U.S. Department
of Transportation
**Federal Highway
Administration**

In Reply Refer To:
HSSI/WZ-293

This is in response to your September 17 e-mail correspondence requesting the Federal Highway Administration's (FHWA) acceptance of your company's ShowMeStand™ ground-mounted portable sign stand as a crashworthy traffic control device for use in work zones and elsewhere on the National Highway System (NHS). Accompanying your letter was the FHWA Office of Safety Design form and an engineering comparison with the Missouri Ground Mounted Temporary Sign Stand, covered in FHWA acceptance letter WZ-219. You requested that we find this device acceptable for use on the NHS under the provisions of National Cooperative Highway Research Program Report 350 "Recommended Procedures for the Safety Performance Evaluation of Highway Features." The Missouri stand was modified as follows:

Missouri Temporary Ground - Mounted Sign Stand

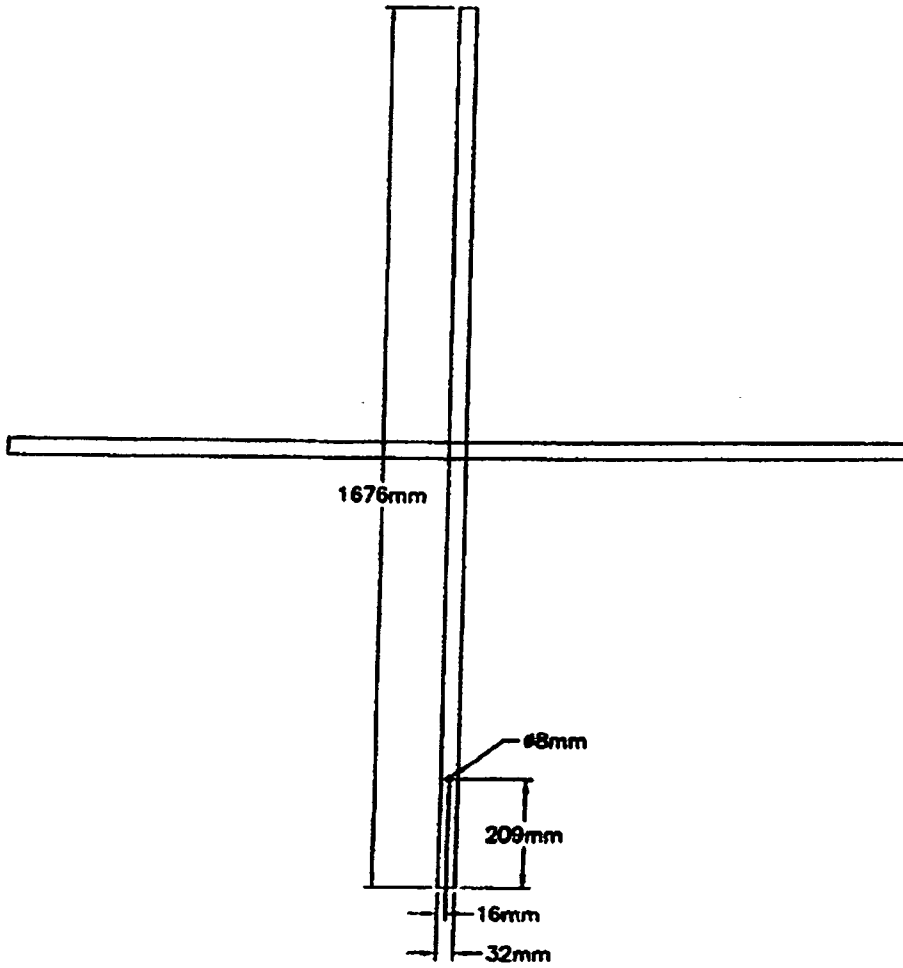
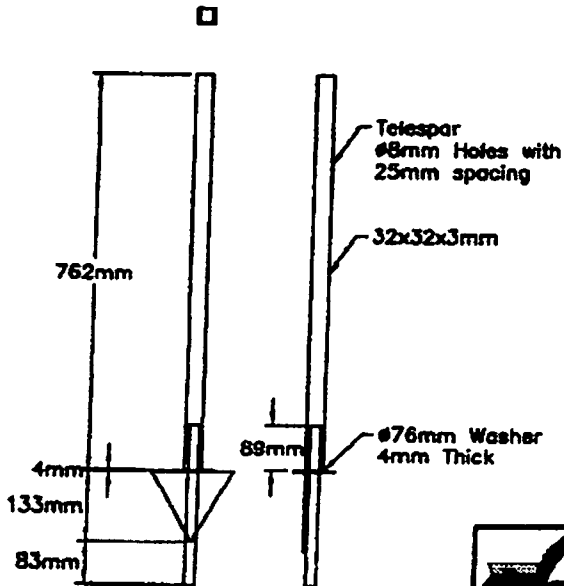
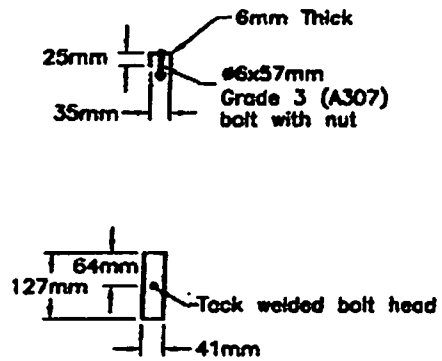
The support tube (30" length galvanized "Telespar" 1-1/4" square perforated steel tube) will be replaced with galvanized or plain (painted) non-perforated 30" length of 1-1/4" square (11 gauge or 12 gauge) steel tube.
